SUBJECT: Historic Area Work Permit #537098, rear addition, chimney removal, and patio installation

MONTGOMERY COUNTY HISTORIC PRESERVATION COMMISSION
STAFF REPORT

Address:	1 East Melrose Street, Chevy Chase	Meeting Date:	6/9/10
Resource:	Contributing Resource Chevy Chase Village Historic District	Report Date:	6/2/10
Applicant:	Norm and Jeanne Asher (Philip Eagleburger, Architect)	Public Notice:	5/26/10
Review:	HAWP	Tax Credit:	None
Case Number:	35/13-10K	Staff:	Anne Fothergill

PROPOSAL: Rear addition, chimney removal, and patio installation

A PROPOSED EAST ELEVATION (PENDING APPROVAL FOR H.A.W.P.)

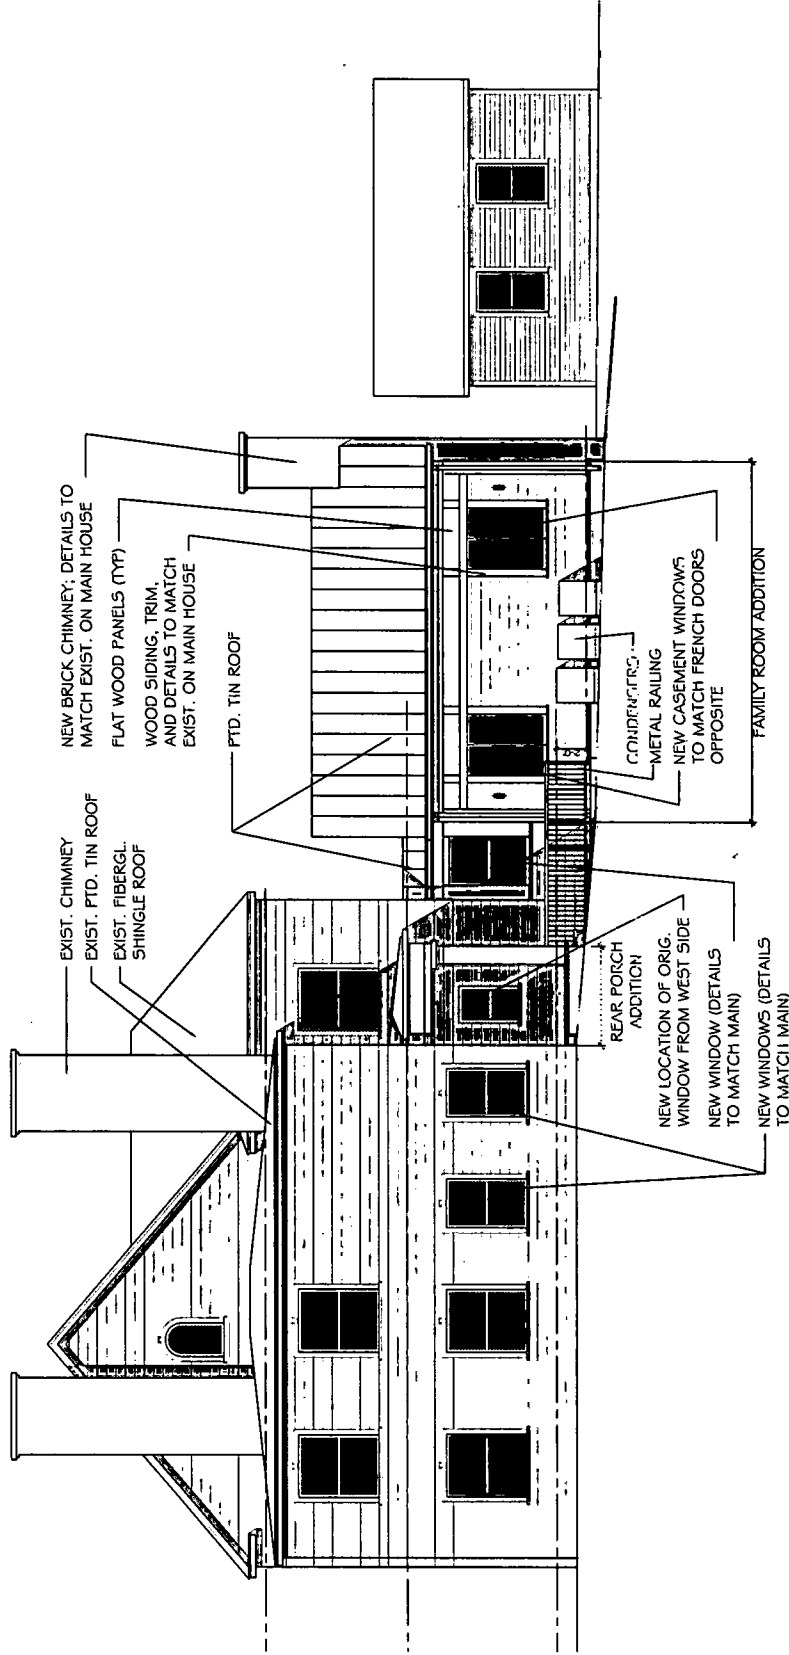
Another concern is the small addition that is proposed on the east side of the original ell next to the new entry porch. However, because the addition is very small, and the original corners of the ell (specifically the northeast corner) will remain visible, staff supports this as it is a very small addition located entirely at the rear of the house.

11 REAR (N) ELEVATION - EXISTING

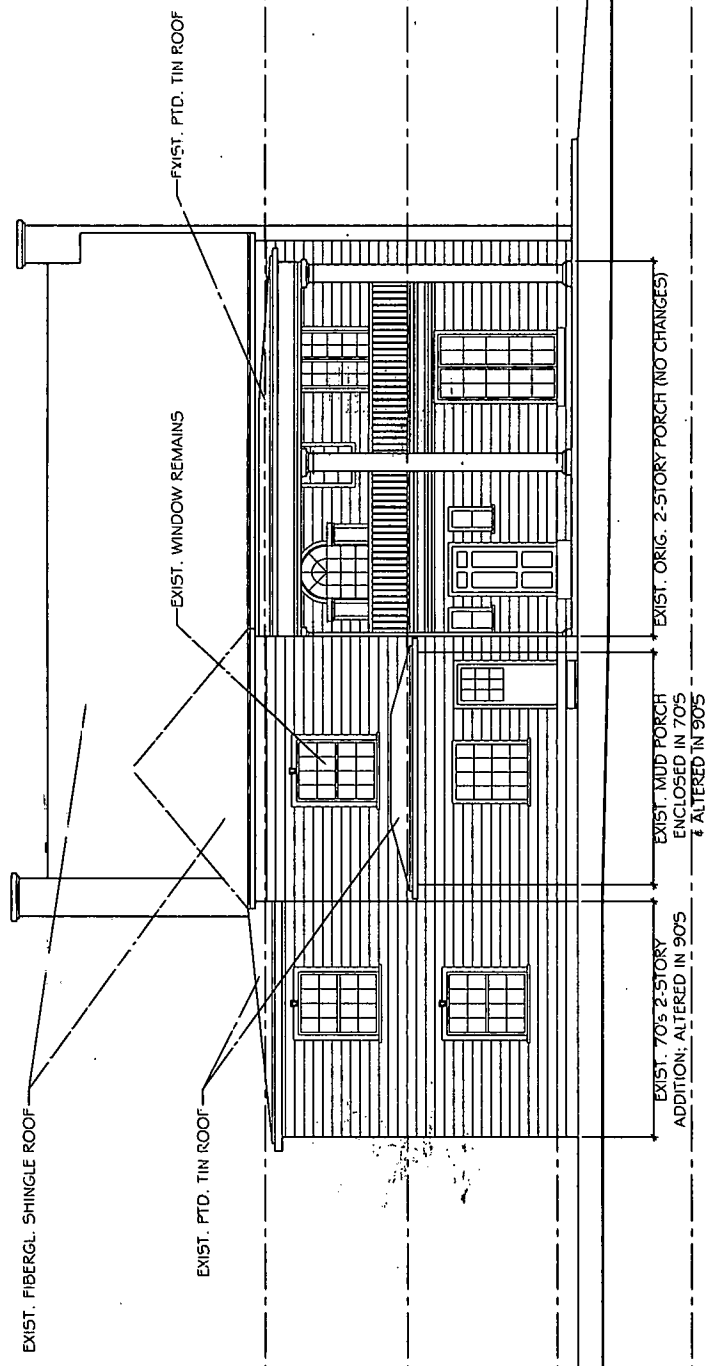
We see that Staff is suggesting the requirement that the applicant keep the third, rear, chimney in place. We also note that the chimney is at the rear and keeping it would interfere with the new kitchen, pantry, stair design. The LAP feels the residents have obviously taken great pains to carefully design these renovations -- both aesthetically and functionally -- and we feel that the project can be approved as submitted. As we have noted before to HPC, we recognize this is an historic district, but it is also a neighborhood for families to live in and use.

Generally the HPC does not support the removal of original chimneys. This chimney is located in an original rear ell, but there are two other, more prominent chimneys on the gable ends of the house. The HPC may support the removal of this less visible and less prominent chimney as a reasonable change to this house and if that is the case the recommended condition of approval could be removed.

- 1) The chimney will not be removed.
